Access Compliance Report Public Rights-of-Way (Curb Ramps)

Main Street: PROSPECT_AVE Cross Street: SHERBROOK_DR Location: SW

ADA ID: RPRK220121134538 Ramp Type: Type 4 - Parallel Initial Pass/Fail: Fail Overall Compliance: No Severity Score: 15

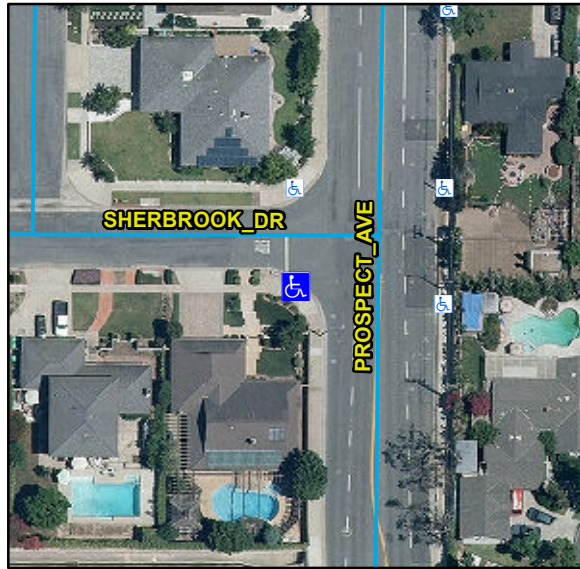
Compliance	Description	Data	Compliance	Description	Data
N/A	Ramp Length LT (in)	126	N/A	Ramp Length RT (in)	127
Yes	Ramp Width LT (in)	107	Yes	Ramp Width RT (in)	107
Yes	Ramp Run Slope LT (%)	5.6	Yes	Ramp Run Slope RT (%)	4.1
No	Ramp Cross Slope LT (%)	6.3	No	Ramp Cross Slope RT (%)	6.2
N/A	Landing Present	N/A	N/A	DWS Provided	N/A
N/A	Landing Length (in)	N/A	N/A	DWS Contrast	N/A
N/A	Landing Width (in)	N/A	N/A	DWS Length (in)	N/A
N/A	Landing Run Slope (%)	N/A	N/A	DWS Full Width	N/A
N/A	Landing Cross Slope (%)	N/A		DWS Offset Type	N/A
N/A	Landing Movement Obstructed?	N/A	N/A	DWS Offset Left (in)	N/A
	Landing Movement Type	N/A	N/A	DWS Offset Right (in)	N/A
N/A	Landing Shared	N/A			
N/A	Clear Space	Yes			
N/A	Clear Space To Crosswalk (in)	N/A			
N/A	Marked Crosswalk 1	No	N/A	Marked Crosswalk 2	No
	Crossing 1 Direction	E		Crossing 2 Direction	N
	Marked Crosswalk 1 Width (in)	N/A		Marked Crosswalk 2 Width (in)	N/A

N/A	Ramp Inside Crosswalk 1	N/A	N/A	Ramp Inside Crosswalk 2	N/A
	Crossing 1 Slope (%)	6.6		Crossing 2 Slope (%)	4.6
	Crossing 1 Cross Slope (%)	0		Crossing 2 Cross Slope (%)	0.2
N/A	Gutter Ponding	N/A	N/A	Curb Slope	7.2
No	Gutter Lip Height (in)	0.25		Road Run Slope (%)	0.2
N/A	Gutter Run Slope (%)	N/A		Road Cross Slope (%)	5
N/A	Gutter Cross Slope (%)	N/A	No	Perpendicular Joint Present	No
Yes	Overall Surface Condition	Acceptable			
	Cross Gutter Present?	No		Spandrel Present?	No
	Replace Cross Gutter?	N/A		Replace Spandrel?	N/A

Remove & Replace Curb Ramp With Two New Directional Ramps or Equivalent. Grind Gutter Lip.
